**SIB 65 01 22**

Knee Air Bag Check Control Message G01 Variants

This Service Information Bulletin (Revision 2) replaces SI B65 01 22 **dated April 2022**.

KNEE AIR BAG CHECK CONTROL MESSAGE G01 VARIANTS

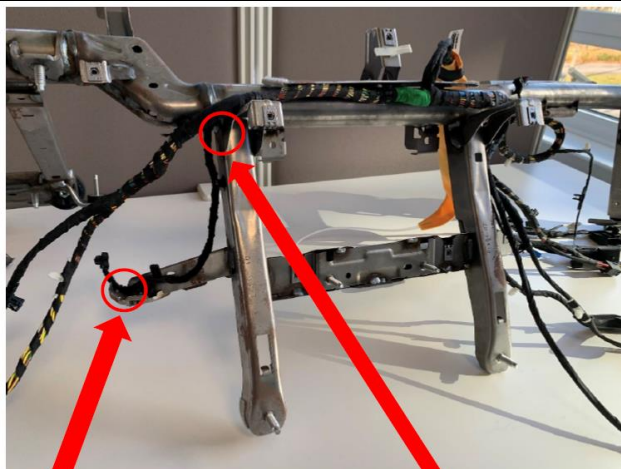
5-Apply felt tape to the 5 locations pictured below.

- For the affected locations 1, 4, 5 the felt tape must wrap around the edge of the metal.

All pictures below show the wiring harness layout and the instrument panel (IP) metal framework removed from the vehicle. These pictures were taken for clarity.

Drivers side locations 1 and 2.

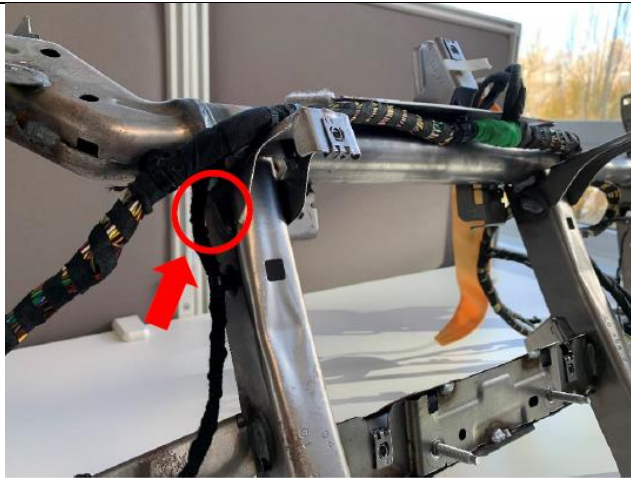
If metal residue or welding residue are visible on the support tube, they must be removed.

Apply felt tape to location 1 on the support tube.
(Felt tape part number **54 34 7 248 700**).

Glue the felt generously onto the support tube or
to the corresponding edge.

Important: The felt must be glued around the
edge!

Passenger side location 3.

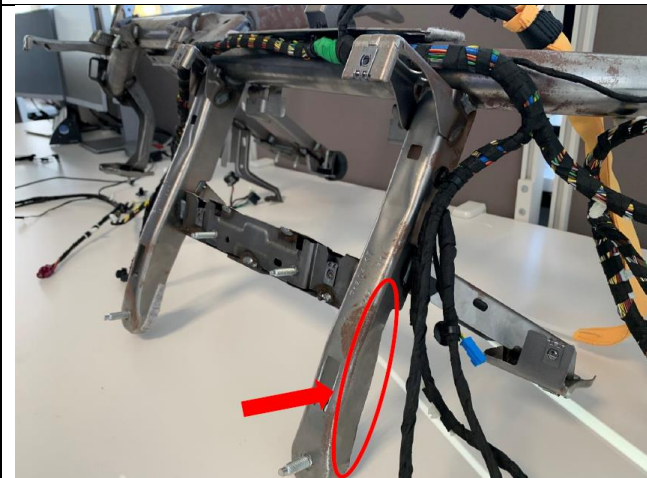
Apply felt tape to location 3 on the support tube.
(Felt tape part number **54 34 7 248 700**).

Glue the felt generously onto the support tube or
to the corresponding edge.

Passenger side location 4.

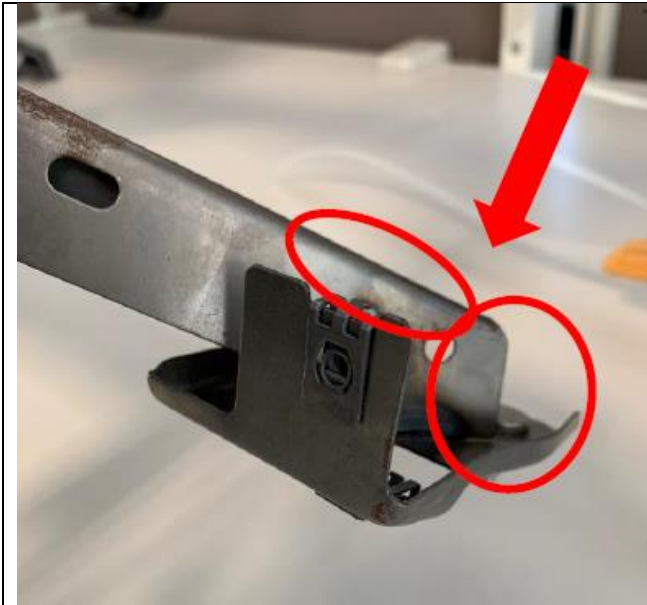
Apply felt tape to location 4 on the support tube.
(Felt tape part number **54 34 7 248 700**).

Glue the felt generously onto the support tube or
to the corresponding edge.

Important: The felt must be glued around the
edge!

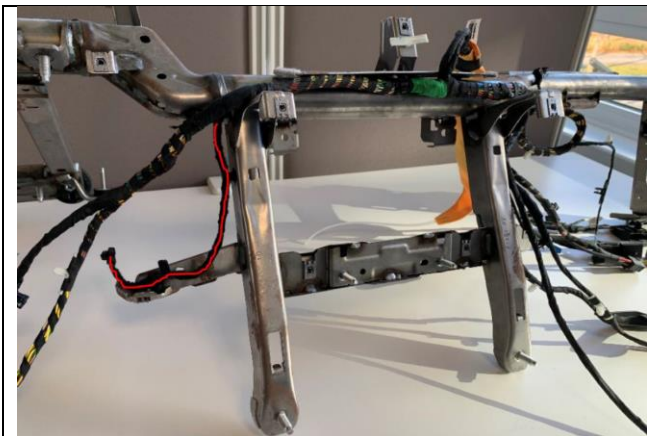
6- Unplug the wiring connector from the ACSM (**A11*2B**).

Reference **Wiring Diagram 'Airbag firing circuits' SP0000061332** and **confirm the wire color and pin number BEFORE cutting these 4 wires at the ACSM connector.**

7- Cut the 4 wires for the knee air bag wiring harnesses near the ACSM connector and tie back the 4 cut wires with a cable strap.

- ACSM Pin 25 (**A11*2B**) goes to pin 1 of driver knee air bag (**B8*1B**).
- ACSM Pin 20 (**A11*2B**) goes to pin 2 of driver knee air bag (**B8*1B**).
- ACSM Pin 5 (**A11*2B**) goes to pin 1 of passenger knee air bag (**B77*1B**).
- ACSM Pin 10 (**A11*2B**) goes to pin 2 of passenger knee air bag (**B77*1B**).

Then pin 2 repair cables into the airbag control unit connector (**A11*2B**) exactly as the previous cables, route one to the knee airbag on the driver's side and the other to the knee air bag on the passenger's side.
